CLEVELAND NATIONAL FOREST POWER LINE REPLACEMENT PROJECTS

MINOR PROJECT REFINEMENT REQUEST FORM

Date Submitted:	02-22-18	Request #:	015
Date Approval Required:	03-09-18	Landowner:	Various
APN:	XXX-XXX-XX, XXX-XXX-XX, XXX-XXX-XX, XXX-XXX-XX		
Refinement from (check all that apply):			
<input type="checkbox"/> Mitigation Measure	<input type="checkbox"/> APM	<input checked="" type="checkbox"/> Project Description	<input type="checkbox"/> Drawing <input checked="" type="checkbox"/> Other
Identify source (mitigation measure, project description, etc.):			
<p>Notice to Proceed (NTP) request #6 was approved by the California Public Utilities Commission (CPUC) and United States Forest Service on August 23, 2017 and Minor Project Refinement (MPR) request #9 was approved by both agencies on November 22, 2017. Since the approval of NTP request #6 and MPR request #9, San Diego Gas & Electric Company (SDG&E) has determined that additional work is required within and adjacent to the Rincon Substation and associated with poles approved in MPR #9.</p> <p>The information in this MPR request discusses SDG&E's requested refinements along Transmission Line (TL) 682.¹ A brief description and justific

**Attachment B:
Comparison Map
TL682 Map 2 of 5**

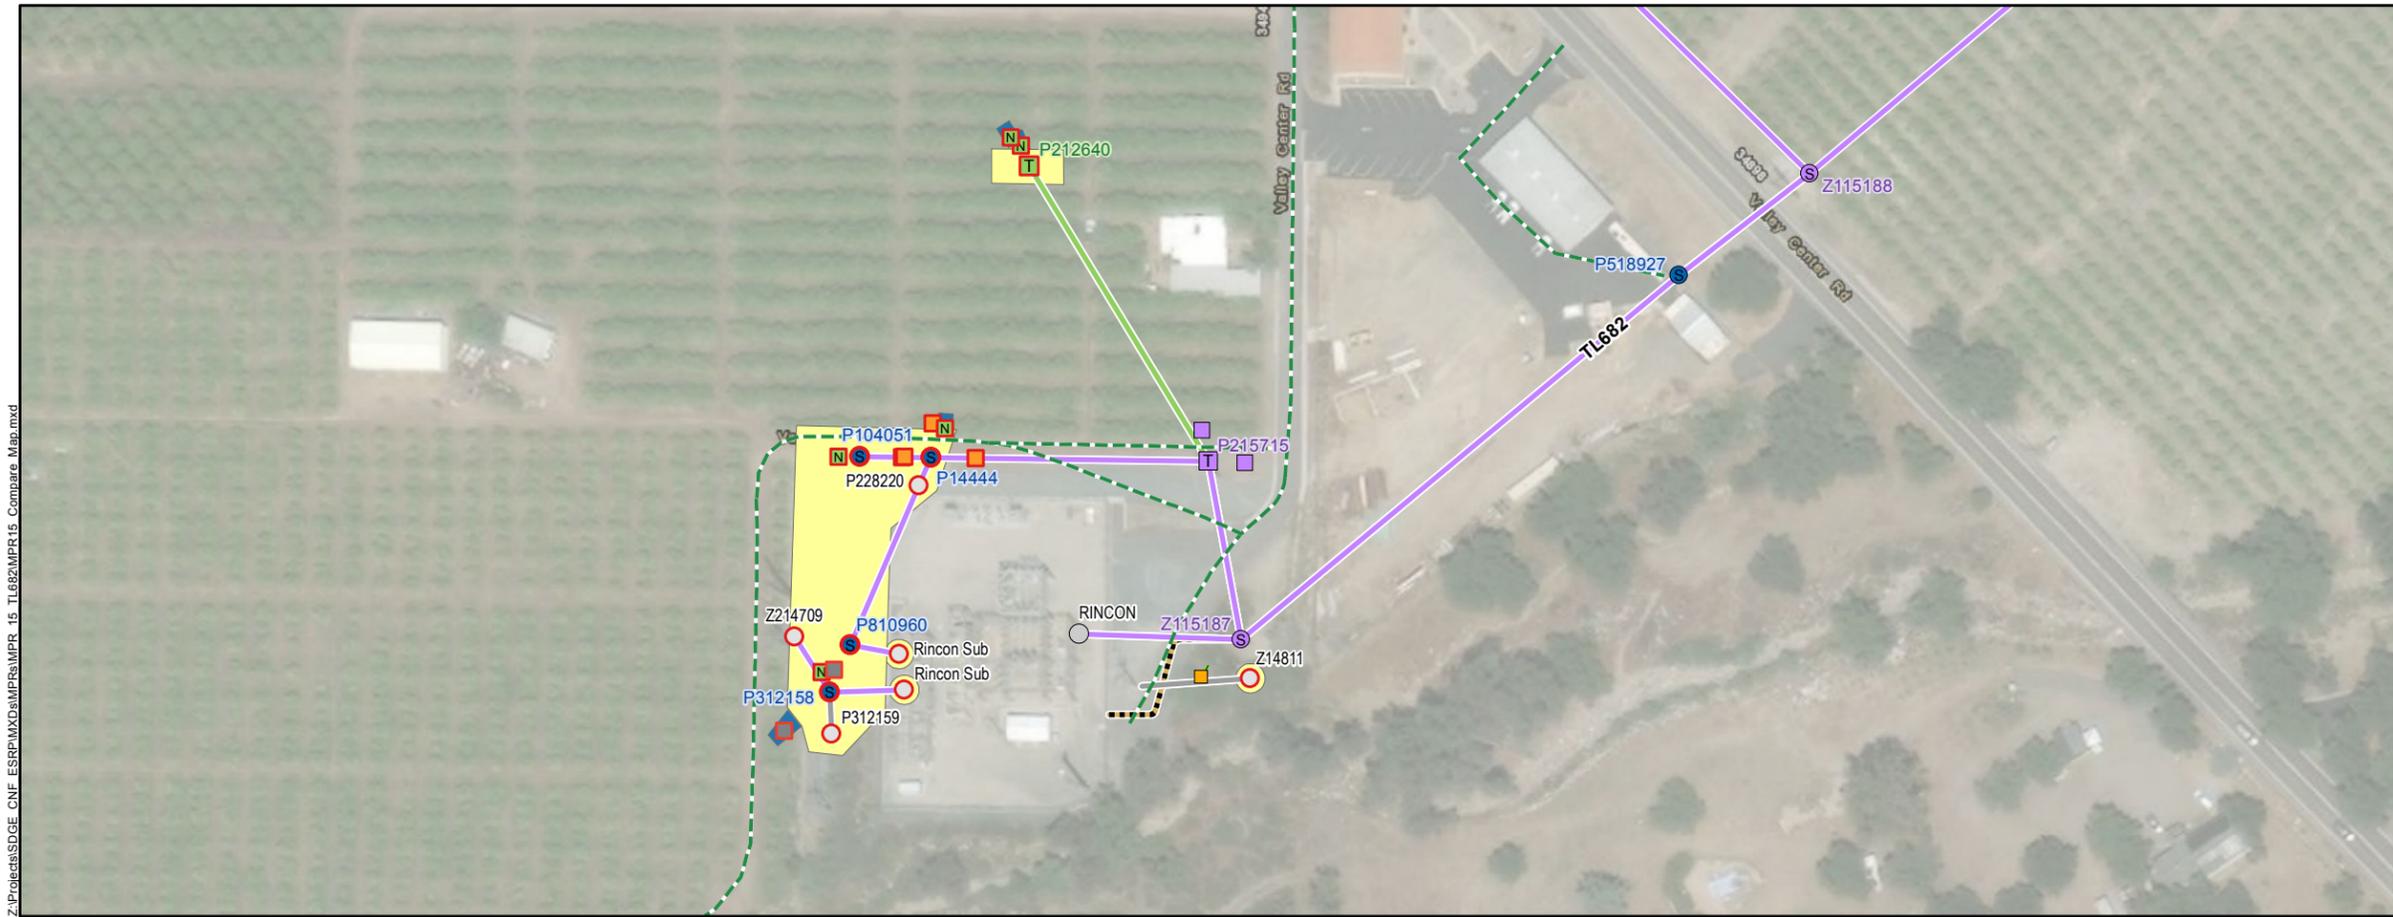
- addition of seven anchors, work at two existing anchors², and removal of three anchors, as well as the associated anchor work areas;
- addition of approximately 0.05 mile of construction-only access roads (vegetation clearing and minor grading may occur) and 0.04 mile of navigation access roads (no vegetation clearing or ground disturbance will be required);
- addition of four 12 kilovolt (kV) wood-to-steel replacement poles, six pole-top-only work locations, and one new steel distribution tap pole, as well as associated temporary pole work areas;
- shifting of Pole P419890 and the associated temporary pole work area by approximately 19 feet³; and
- removal of the existing Pole P258156S⁴ and inclusion of associated temporary pole work area.

Attachment B: Comparison Map depicts the facilities and workspaces approved in MPR #9, NTP #6, and various Workspace Adjustments in comparison to the requested refinements, as described in this MPR request. The activities associated with the construction and utilization of the refinement areas will occur in the same manner as described in the Final EIR/EIS for construction of the Project. The requested refinements will result in an increase of up to 0.52 acre of temporary impacts (of which approximately 0.01 acre is classified as native vegetation) and less than 0.01 acre of permanent impacts.⁵ The breakdown of the temporary and permanent impacts is summarized in Attachment C: Impacts Table.

**Attachment B:
Comparison Map
TL682 Map 4 of 5**

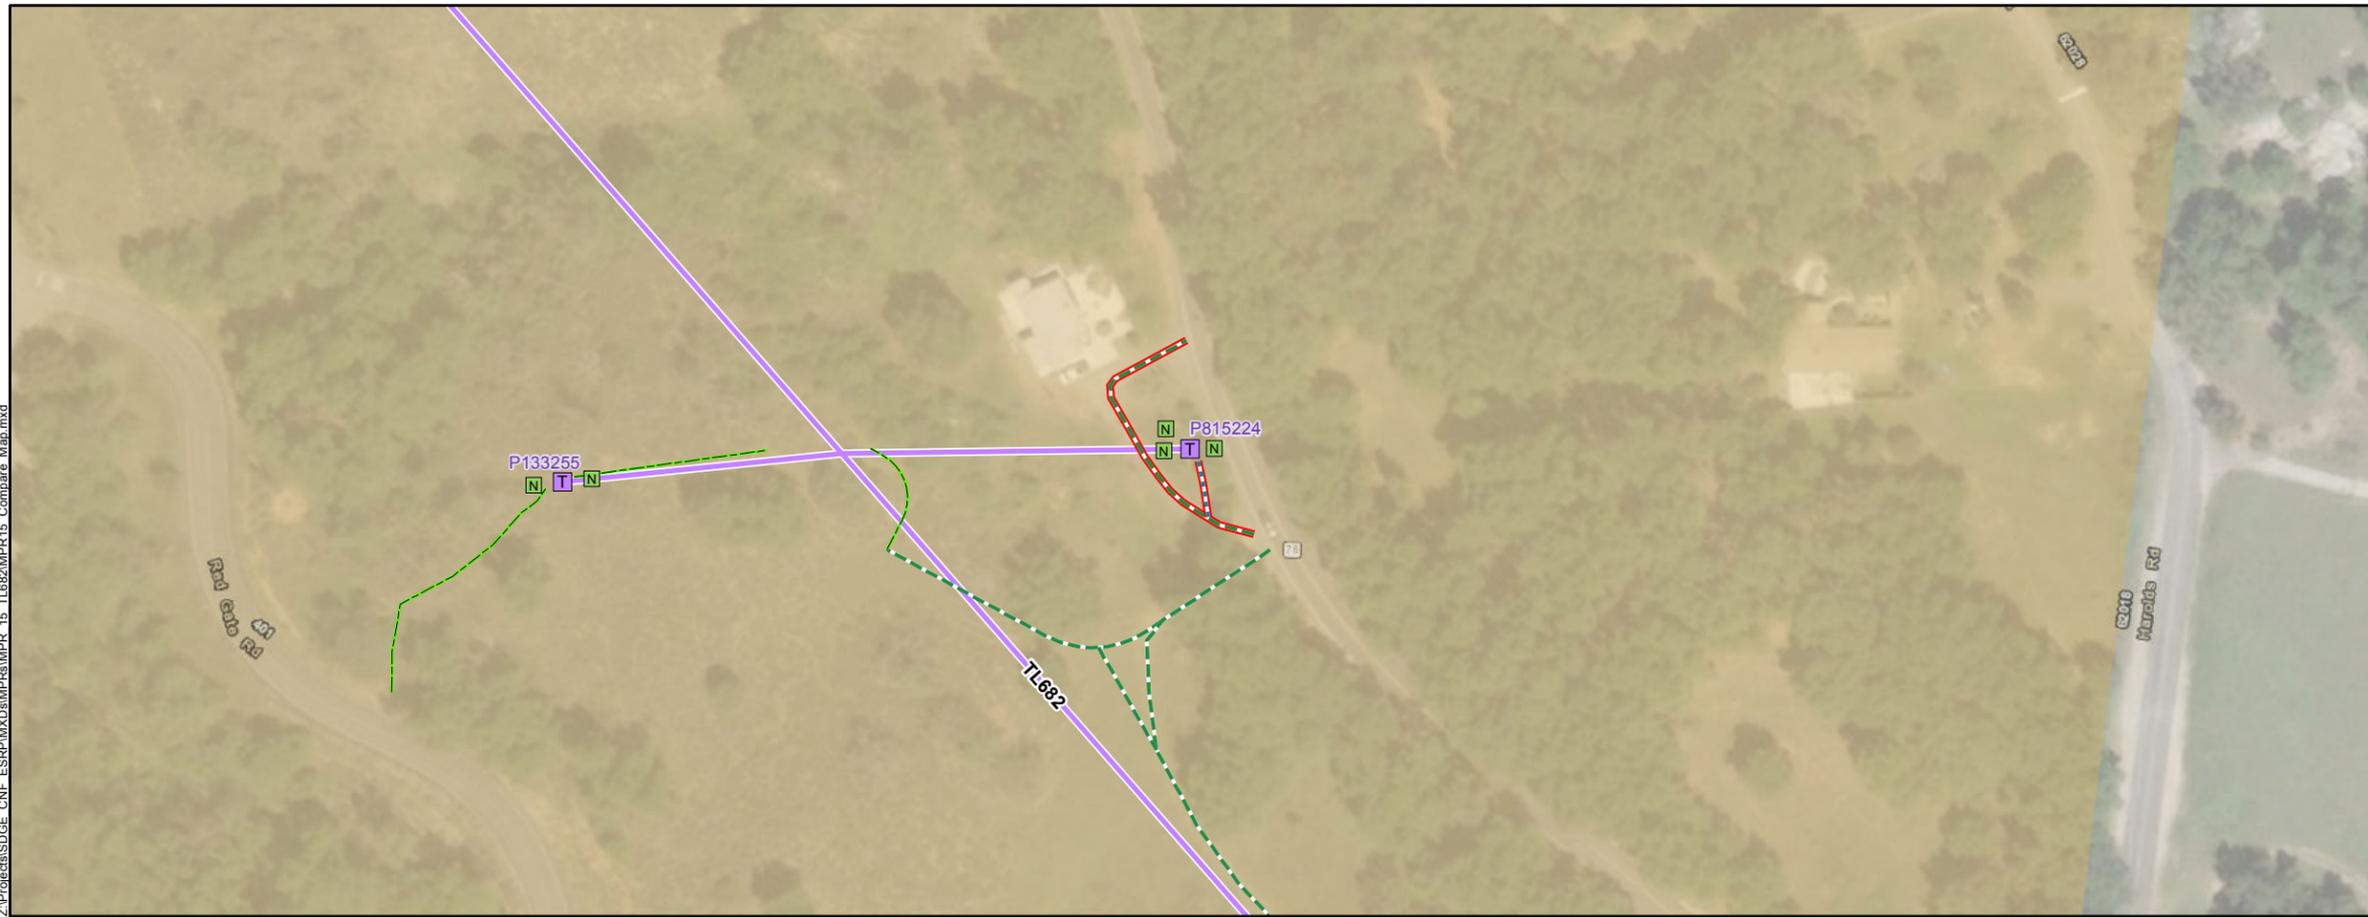
- The construction-only and navigation access roads at Pole P815224 will minimize lane closures and use of the State Route 76 shoulder while completing pole and anchor hole digging and pole setting, as well as avoid substantial tree trimming and removal during pole setting.
